Subject: ISSUANCE OF AMENDMENT NO. 12 TO FACILITY OPERATING LICENSE NO. NPF-38  
FOR WATERFORD 3

ISSUANCE OF AMENDMENT NO. 12 TO FACILITY OPERATING  
LICENSE NP. NPF-38 FOR WATERFORD 3

AMENDMENT TO FACILITY OPERATING LICENSE

Amendment No. 12  
License No. NPF-38

FIGURE 3.1-2  
CEA INSERTION LIMITS VS THERMAL POWER

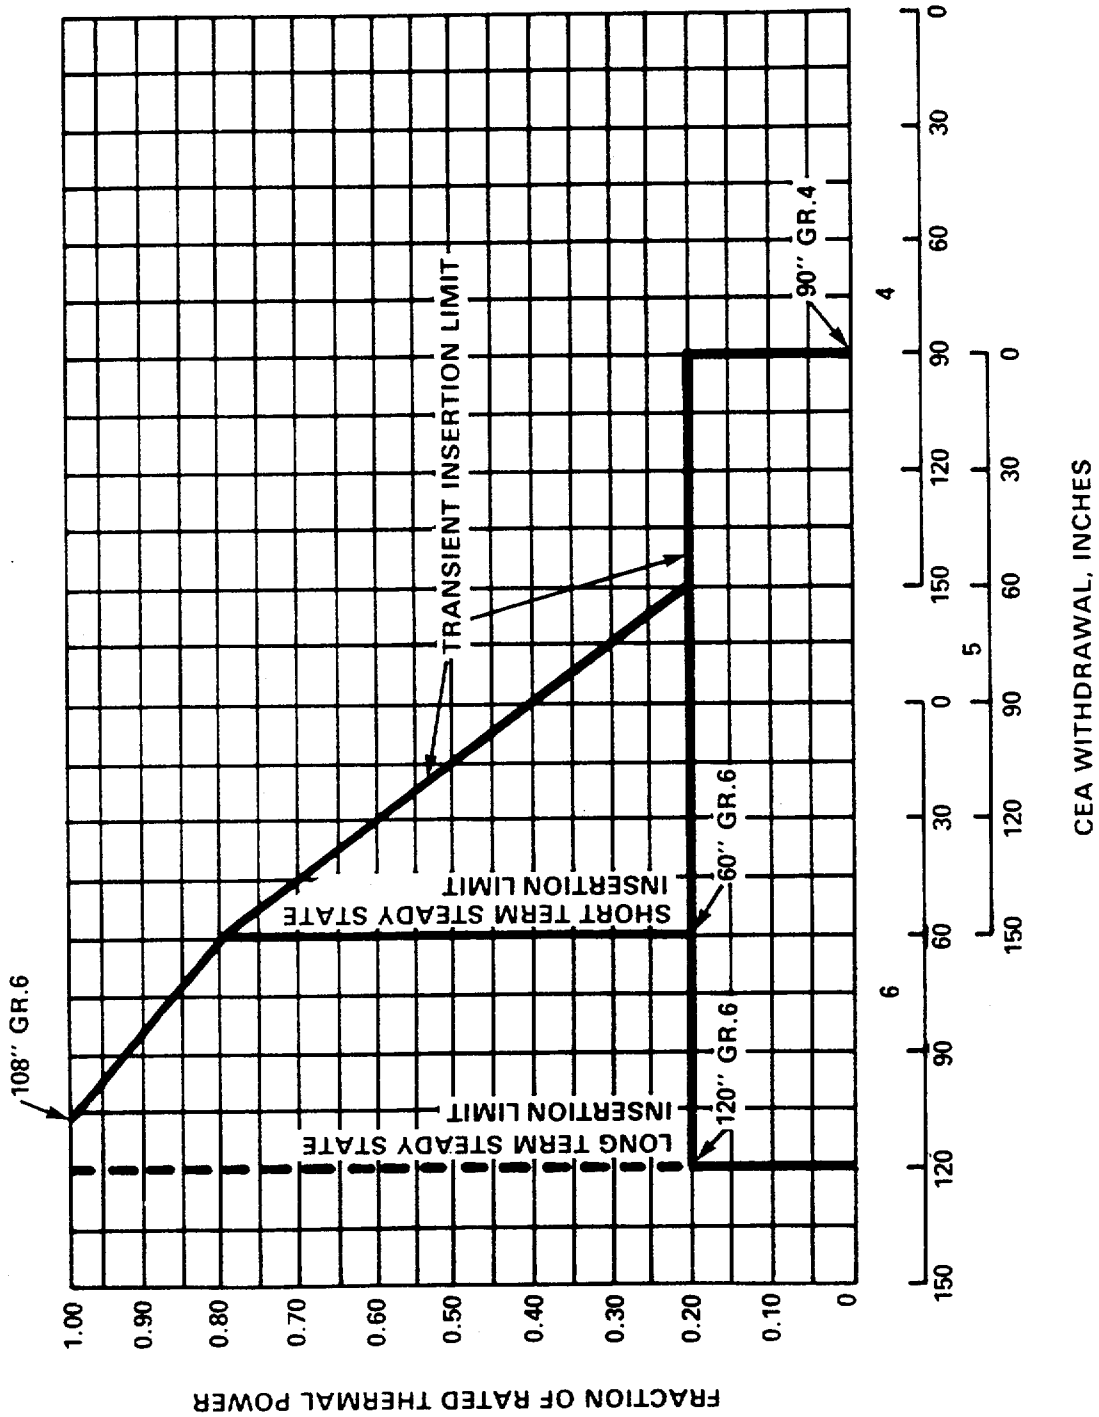
The proposed change would revise Figure 3.1-2 of Technical Specification 3.1.3.6, "Regulating CEA Insertion Limits," and Bases B 3/4.1.3.

Technical Specification 3.1.3.6 imposes limits on the allowable position of the regulating CEA groups and on the allowable time interval within a given CEA position range. The CEA insertion limits are given by Figure 3.1-2. The greater the CEA insertion, the larger the positive reactivity addition is if the CEA were to be withdrawn. Therefore, these limits provide protection against events such as the CEA ejection accident by limiting how far CEAs may be inserted into the core. Figure 3.1-2 also limits CEA insertion to a level that results in acceptable pin power peaking factors and maintains adequate shutdown margin.

The proposed change would increase the maximum allowable insertion of Group 6 by 7.5 inches during long term steady state operation. In addition, it would reduce the allowable insertion during transient operation for Groups 5 and 6 above 20% power. Between 0 and 20% power, insertion of Group 4 would be limited to 6 inches. These revised limits were used to calculate radial power distributions for rodded configurations and net available scram worths as well as other safety related data such as ejected CEA and dropped CEA worths for Cycle 2. Since the calculations used to obtain the revised limits were performed with accepted methods and the appropriate values were used in the safety analyses, the proposed changes are acceptable.

During low power operation, Axial Shape Index control is proposed by maneuvering Groups 5 and 6 essentially tip-to-tip within the limits established by the Figure 3.1-2. Tip-to-tip operation of Groups 5 and 6 means that these groups can be inserted into the core by essentially the same amount. An additional statement is included in the Bases to clarify that this operation is acceptable. Since the CEA groups will always be limited to the transient insertion limits shown in Figure 3.1-2 and, in practice, Group 5 will be slightly more withdrawn than Group 6 to avoid a potential core protection calculator CEA sequence error reactor trip, the proposed tip-to-tip operation is acceptable.

FIGURE 3.2-1a

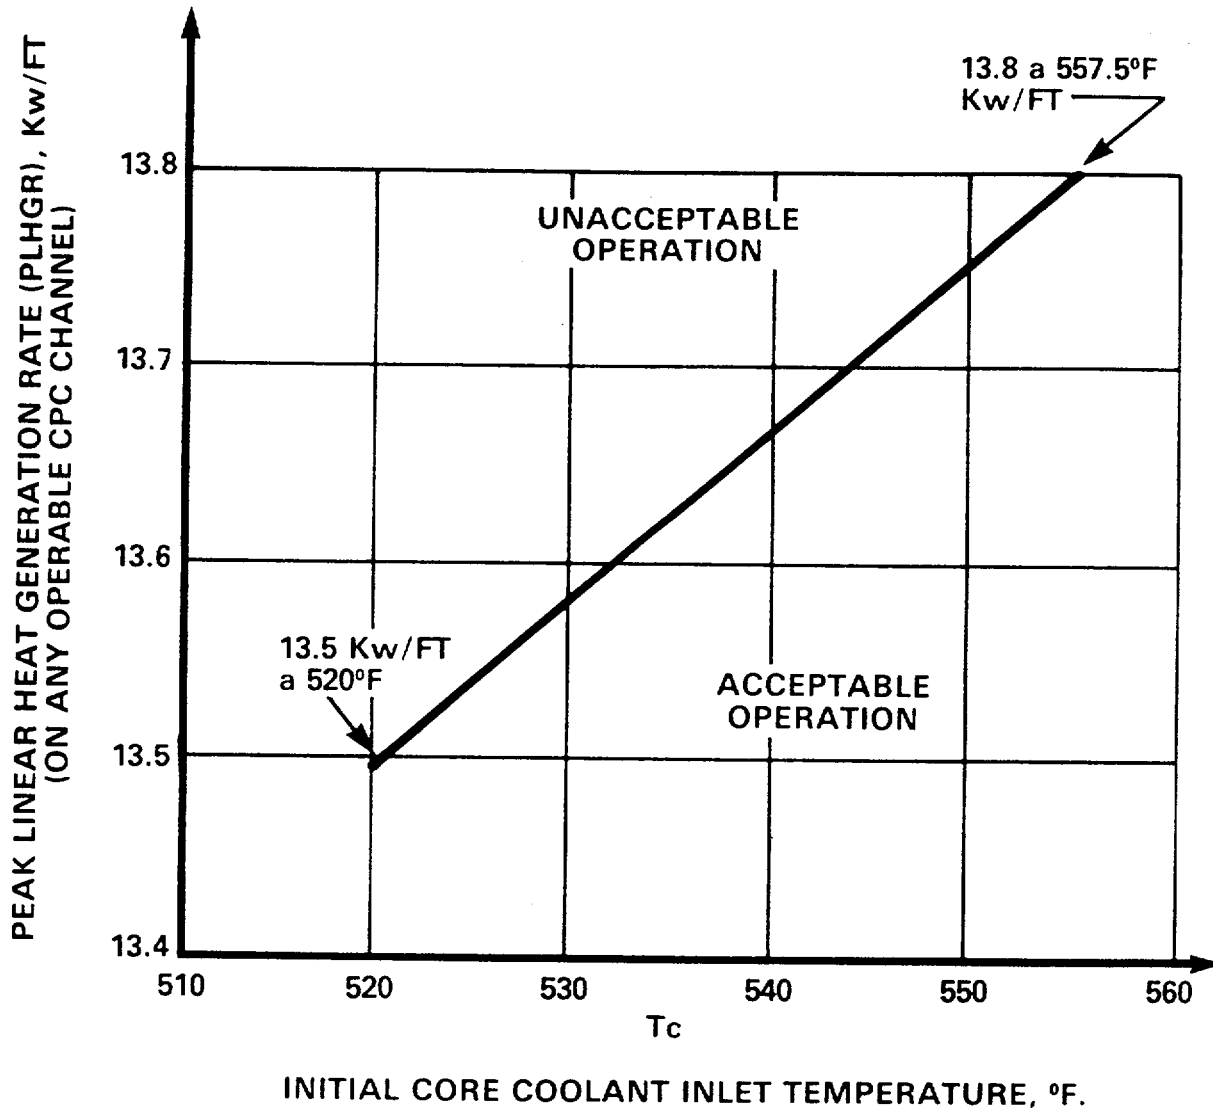
When the core protection calculators are used to monitor the core power distribution, the LHR must be maintained below the maximum allowable value shown in Figure 3.2-1a. This Figure takes credit for the large conservatisms built into the CPCs for transient protection which are not all required when

the CPCs are being used for monitoring. Figure 3.2-1a would be modified as a result of changes in the Cycle 2 core parameters. When the CEACs are inoperable, a penalty is applied automatically in the CPC calculation of linear power density which assures a conservative LHR calculation for monitoring as well as protection. However, this penalty is no longer large enough to maintain adequate LHR margin for Cycle 2. Therefore, Specification 3.2.1c, which allows the CPCs to automatically monitor the LHR, has been deleted. This is acceptable. Also, there is no additional penalty when the CEACs are inoperable since the LOCA analyses, which are used to determine the LHR limit, are not impacted by the operability of the CEACs. Therefore, the same LHR limit applies for both operable and inoperable CEACs. The modification of Specification 3.2.1b and the associated Figure 3.2-1a, such that they now apply whether or not any CEACs are operable, is, therefore, acceptable.

FIGURE 3.2-2

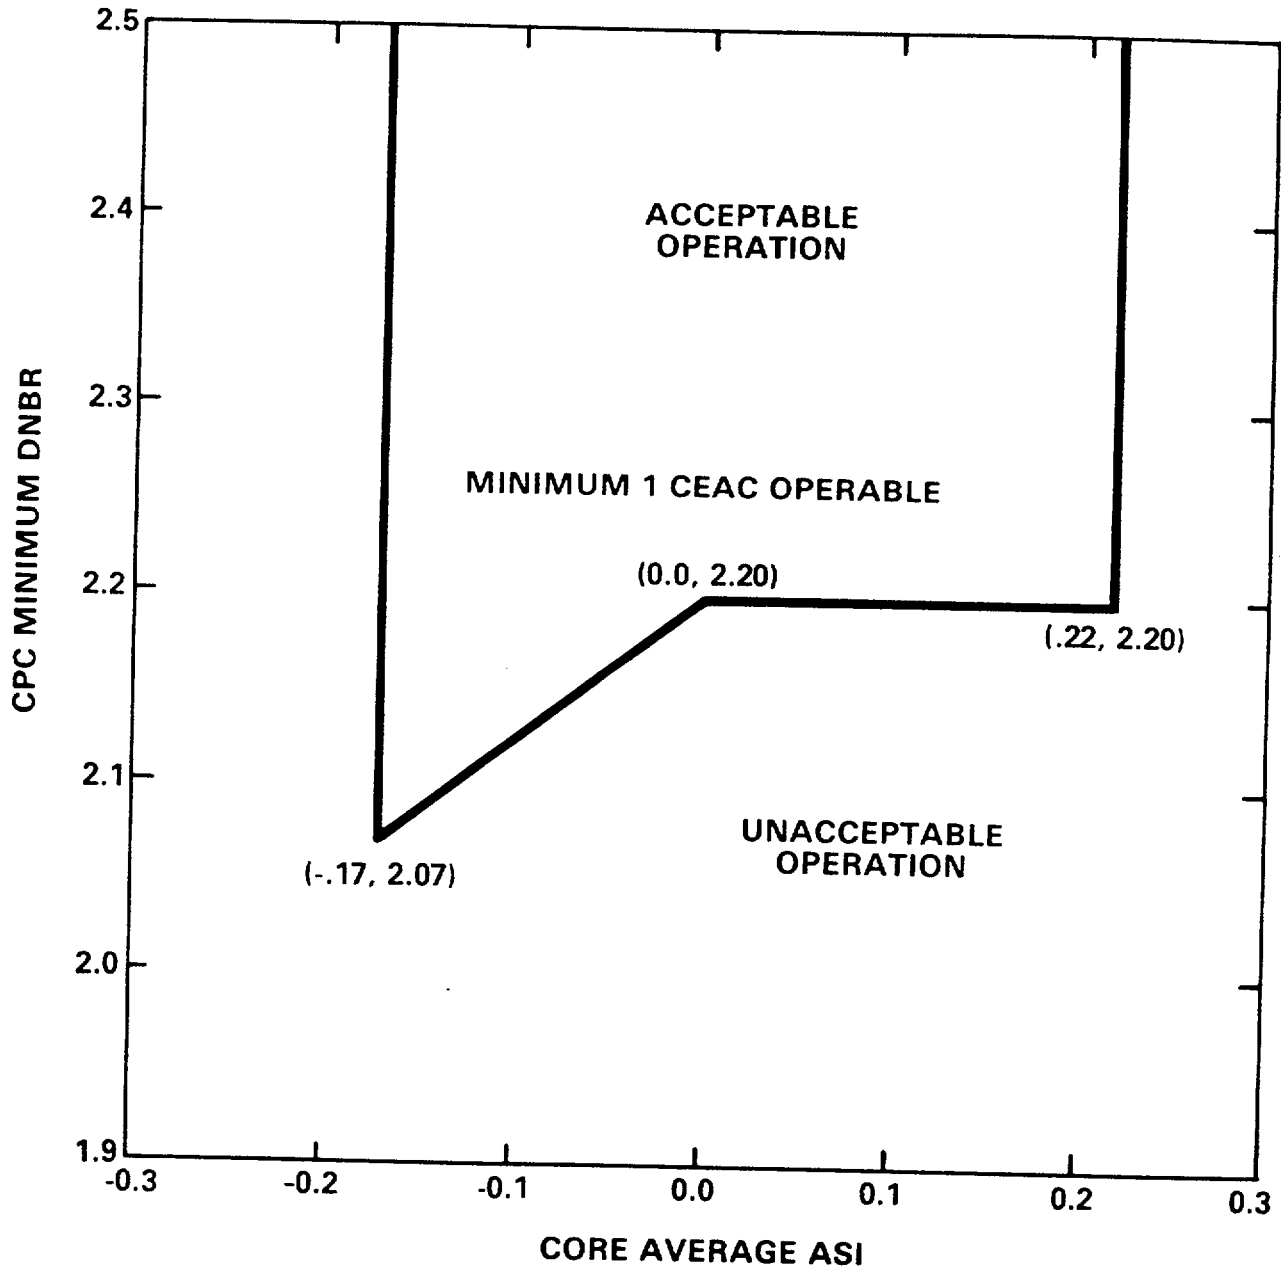
The proposed change would revise the core operating limit supervisory system out-of-service departure from nucleate boiling ratio limit lines in Technical Specification 3.2.4, "Power Distribution Limits, DNBR Margin" and the associated Bases. The proposed change would also delete the rod bow penalty given as a function of burnup in Surveillance Requirement 4.2.4.4 and currently imposed on the core protection calculator calculated DNBR.

Whenever COLSS is out-of-service, the CPCs are used to perform the same monitoring function. However, the extra conservatisms built into the CPC for transient protection are not all required when the CPCs are being used for monitoring. In order not to affect the CPC transient protection, these conservatisms are not taken from the CPC but are credited in the COLSS out-of-service limits given in Figures 3.2-2 and 3.2-3. A reevaluation of the limiting AOOs performed as part of the Cycle 2 safety analyses has verified that by maintaining the margin shown in the proposed revised Figures 3.2-2 and 3.2-3, sufficient margin exists to ensure that the limiting Cycle 2 AOO will not result in fuel failure. The proposed revisions to these figures are, therefore, acceptable.
